P 538094
A _____

Tax ID # 04-593660
ON-SITE SEWAGE DISPOSAL SYSTEM
HOWARD COUNTY HEALTH DEPARTMENT
BUREAU OF ENVIRONMENTAL HEALTH

SUBDIVISION: Cattail Overlook Sec II Ph II LOT NUMBER: 19

ADDRESS: 14865 Meriwether Drive PROPERTY OWNER: Toll MD VIII LP

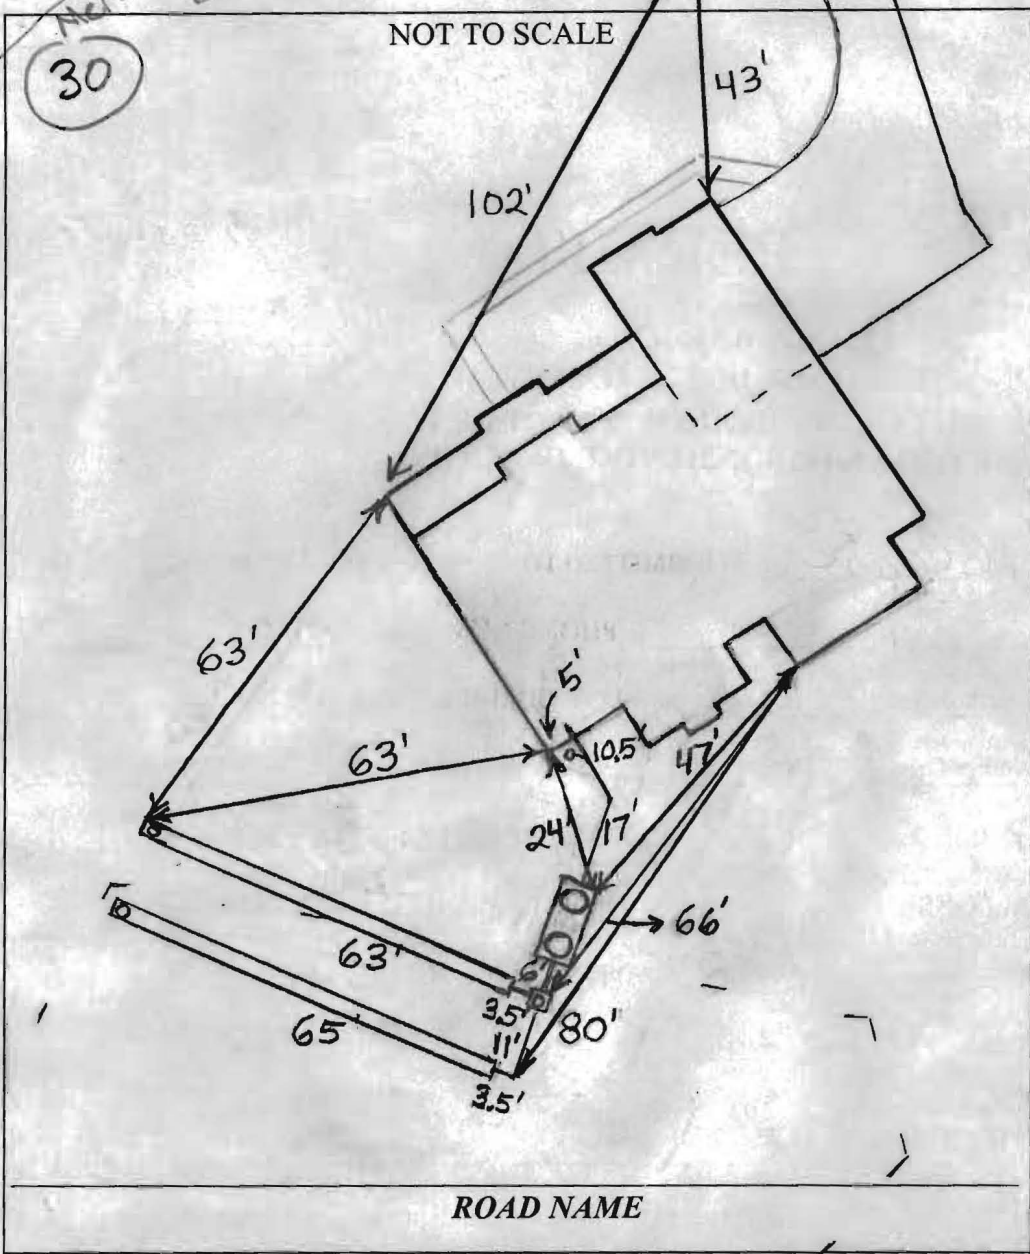
10/25/12 Keep tank 20' from house. Run 2x65' trenches on constant grade SRA running north. Trenches shallowed to 5'. Call for inspection (30)

10/26/12 System finished, O.K. to backfill. (BB)
